ORIGINATION FORM

Proposed Revisions to a Standard Plans Index (Please provide all information — Incomplete forms will be returned)

Index Number: 715-003
Sheet Number (s): All (1-3)
Index Title: Utility Conflict Pole

New Standard Plans Index for a different light pole type.

FIXTURE ARM ASSEMBLY

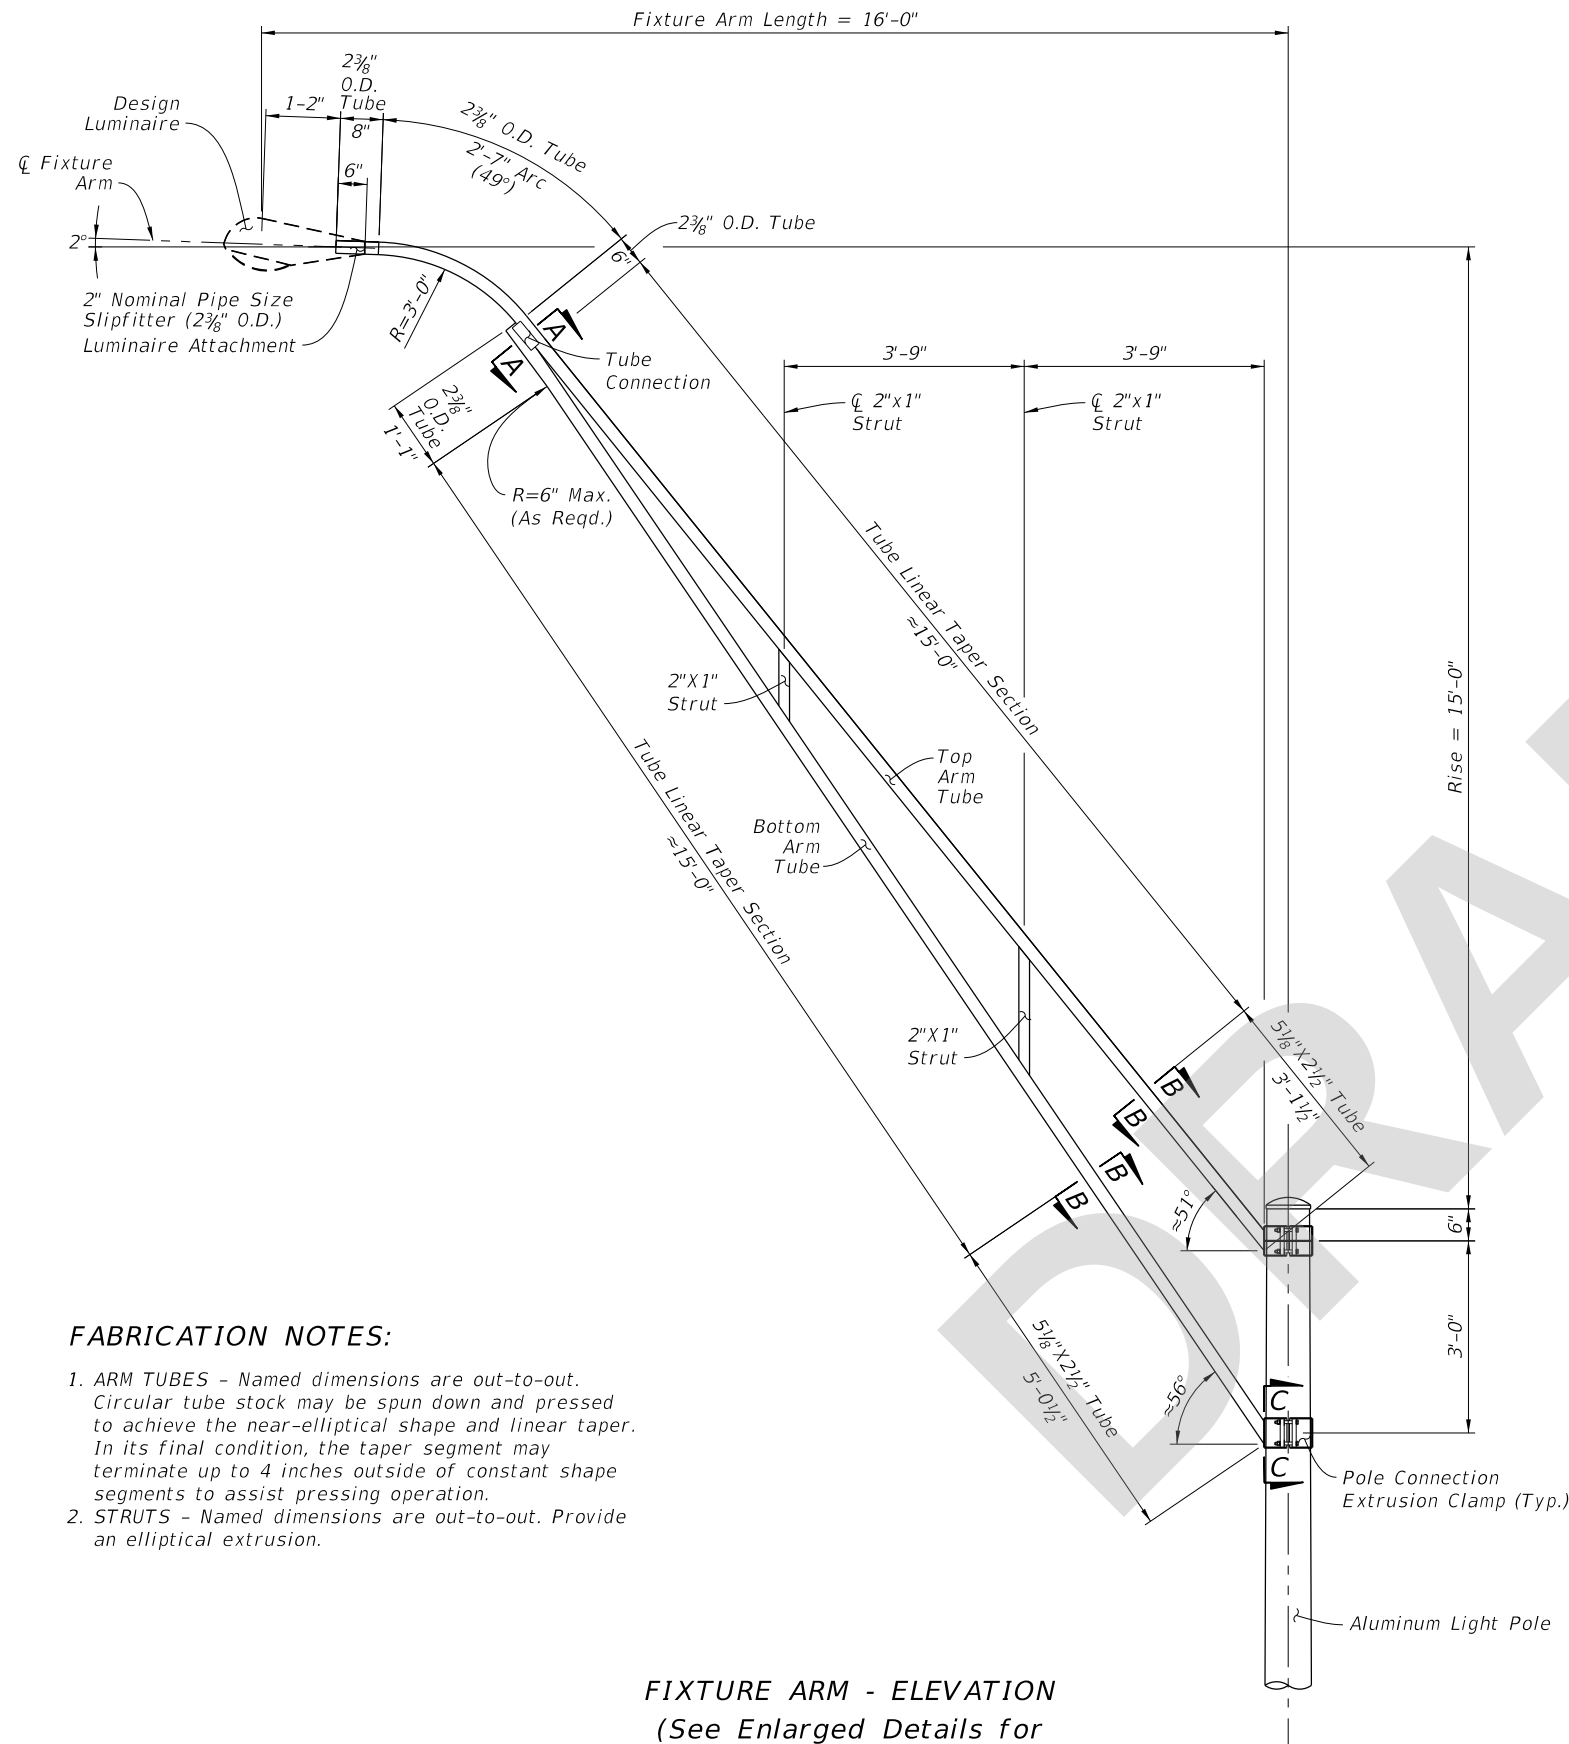
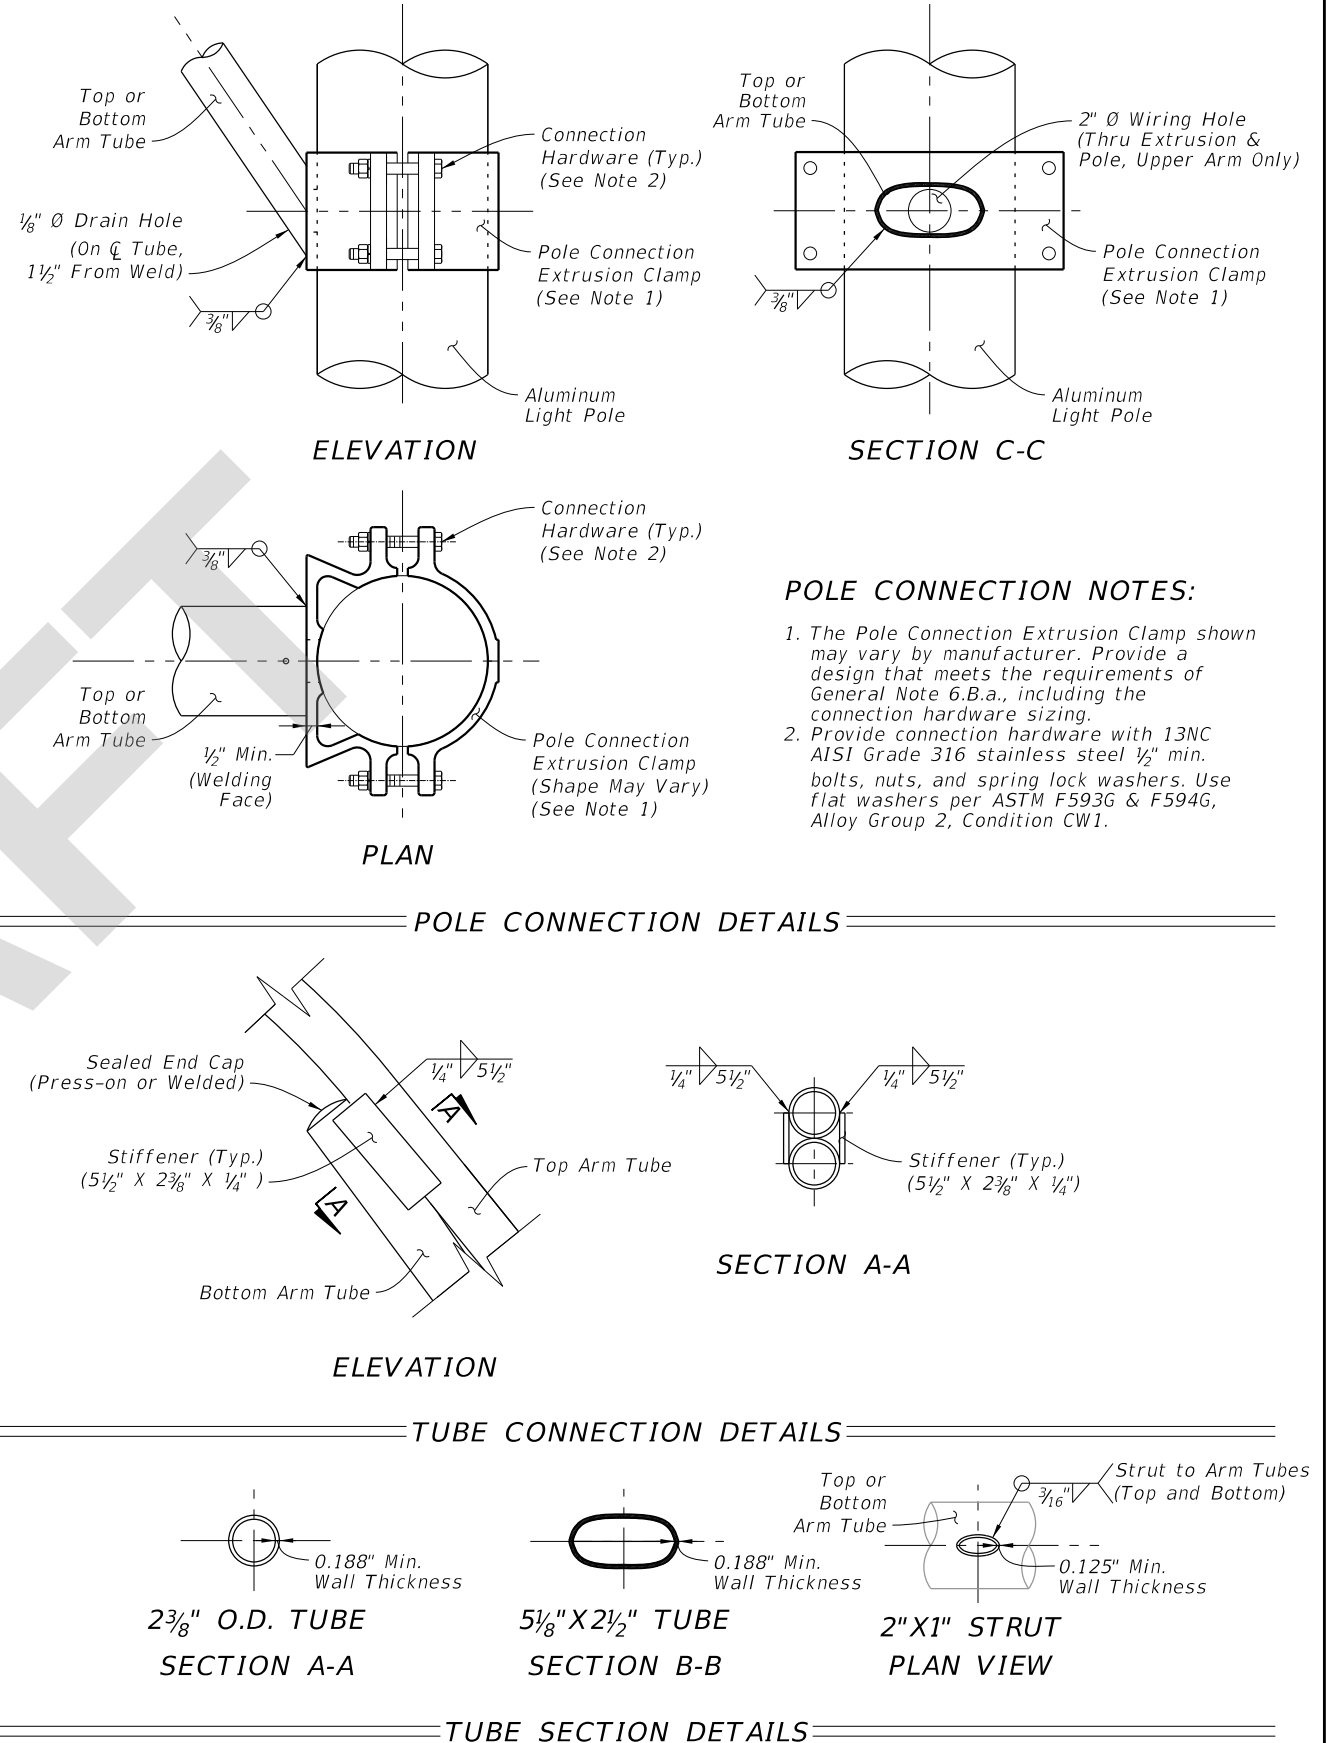
This new pole type has fixture arm dimensions of 16-foot horizontal by 15-foot rise to assist designers with avoiding overhead power lines and other utilities when conventional poles won't fit these project constraints.
